SUNDRY NOTICES AND REPORTS ON WELLS

LaMunyon Federal #3

30-025-10815

RE: Plugging and Abandonment Requirements, Conditions of Approval

OXY USA Inc. - Proposed
LaMunyon Federal #3
API No. 30-025-10815

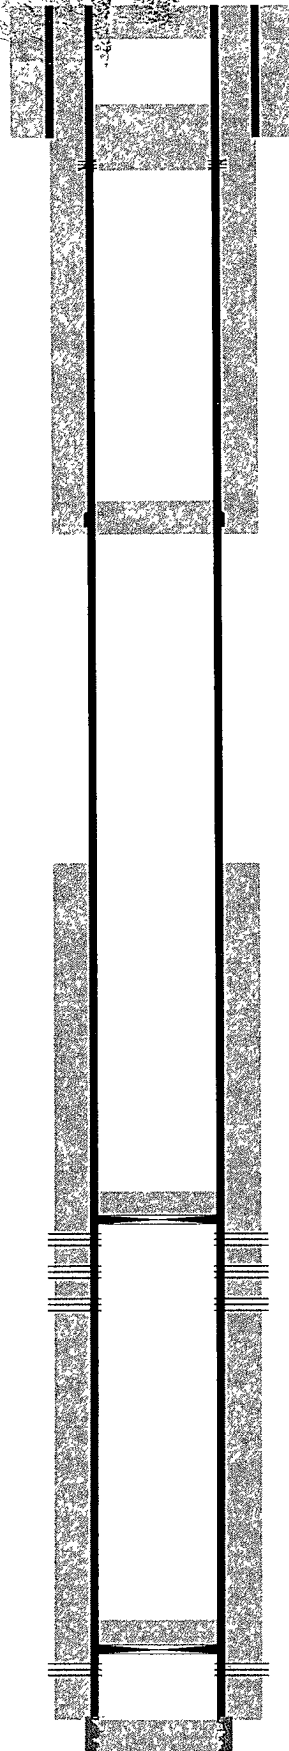
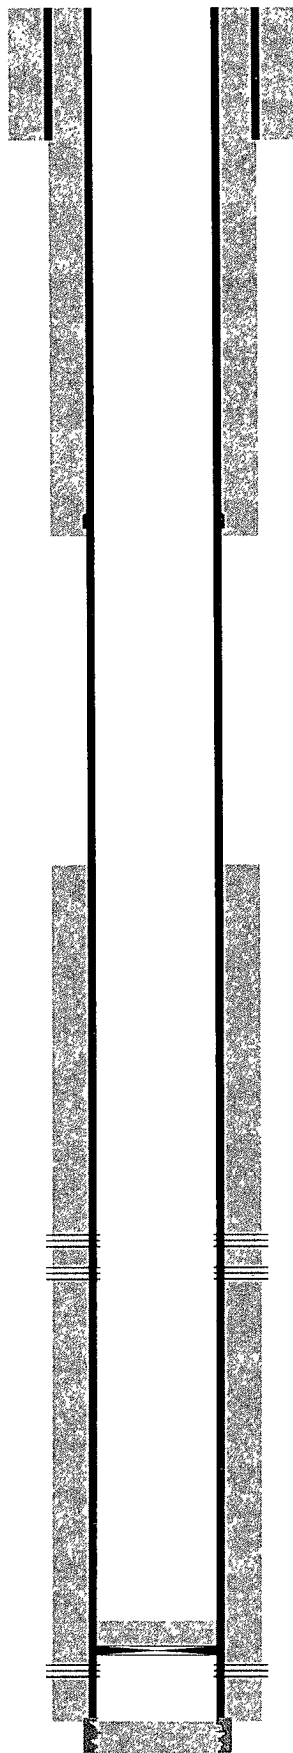
1. OK
2. Tag to confirm depth of CIBP before pumping – Otherwise OK (Perfs – BOS)
- 2a. Perf and squeeze a plug from 1815'-1695'. If injection rate cannot be established, spot plug 50' below perfs. WOC and tag at 1695' or shallower. (TOS)
3. CHANGE: Perf and squeeze plug from 1130'-1020'. If injection rate cannot be established, spot plug 50' below perfs. WOC and tag at 1020' or shallower. (DV Tool)
4. OK (Casing shoe)
5. OK (Surface)
6. Submit a subsequent report to the BLM.
